**Amendments to the Drawings:**

**DOCKET NO.: HITACHI-0015**  
**Serial No.: 09/848,916**  
**Amdt. dated May 20, 2005**  
**AMENDMENT**  
**Annotated Version**

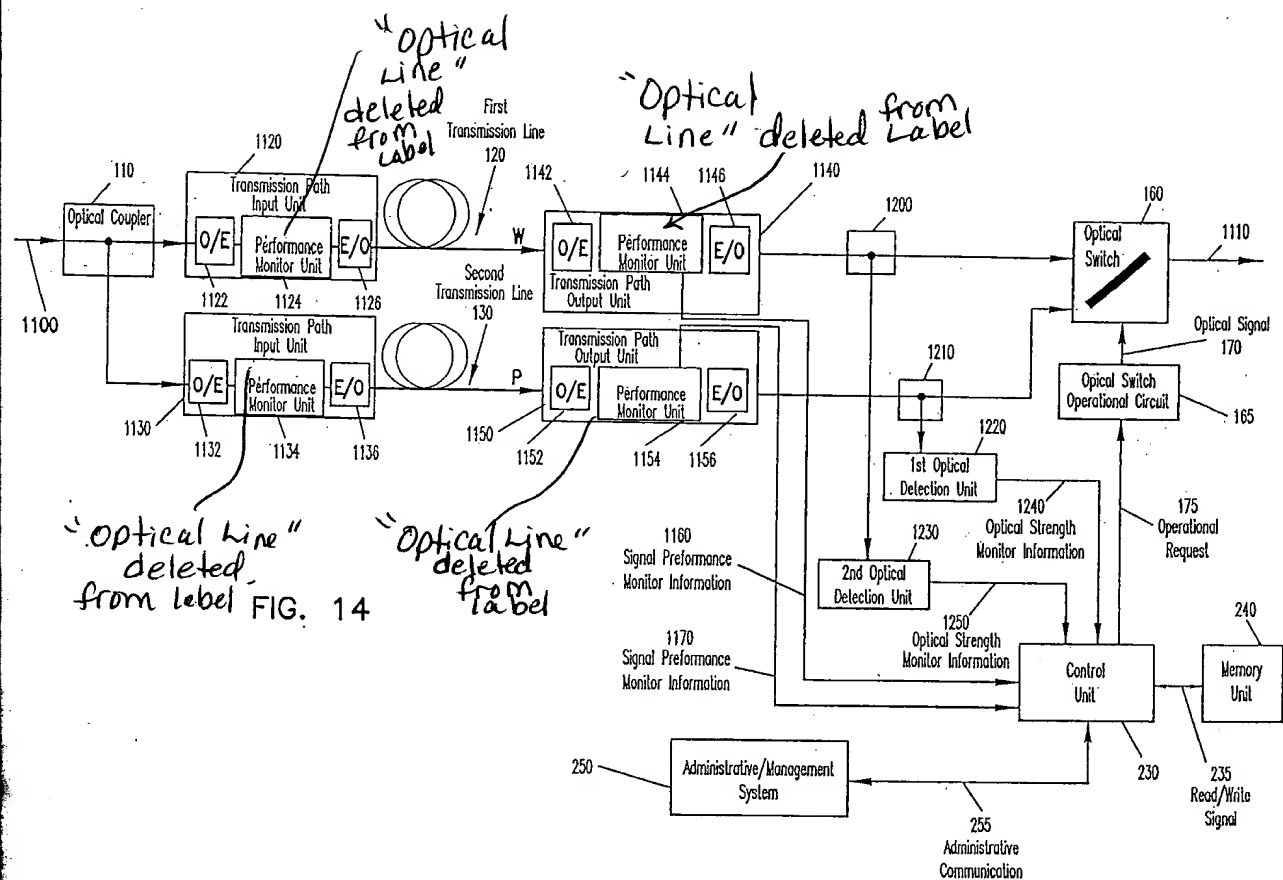
In Figs. 14-16, please change elements 1120, 1134, 1144 and 1154 to read "Performance Monitor Unit."

In FIGURES 14, 15 and 16, reference numerals 1124, 1134, 1144, and 1154 are now labeled as "Performance Monitor Unit." Similarly, in claims 16, 17 and 25, "optical line performance monitor unit" has been amended to "performance monitor unit." Lastly, the corresponding portions of the specification with respect to Figs. 14, 15 and 16 have been amended to refer the numerals 1124, 1134, 1144 and 1154 as "performance monitor unit."
